Notification Date: November 19, 2019
Effective Date: January 1, 2020¹

PRODUCT CHANGE NOTIFICATION

Unique Default Password for new Routers

Figure 1: Router's Label with the Unique Default Password

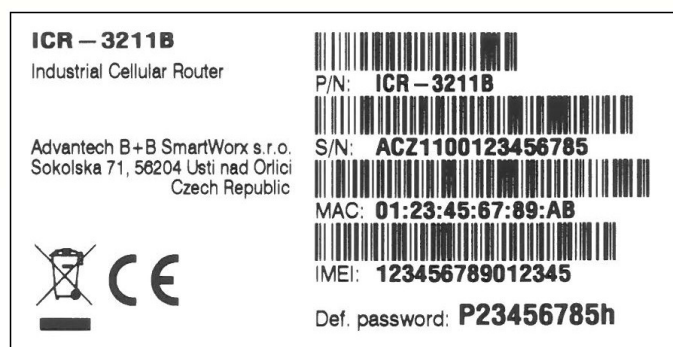
Detailed Description of the Change: To increase security in general and concerning the California [Senate Bill No. 327](#), all Advantech routers will be produced with a unique default password. This password will be printed out on the router's label as shown in the figure below. The format of the password is ***P<last 8 digits of the serial number>h***.

Anticipated impact on Fit, Form and Function: Since the effective date, each and every router will have different and unique password set right from the factory. This will impact systems counting on default 'root' password set in new router units.
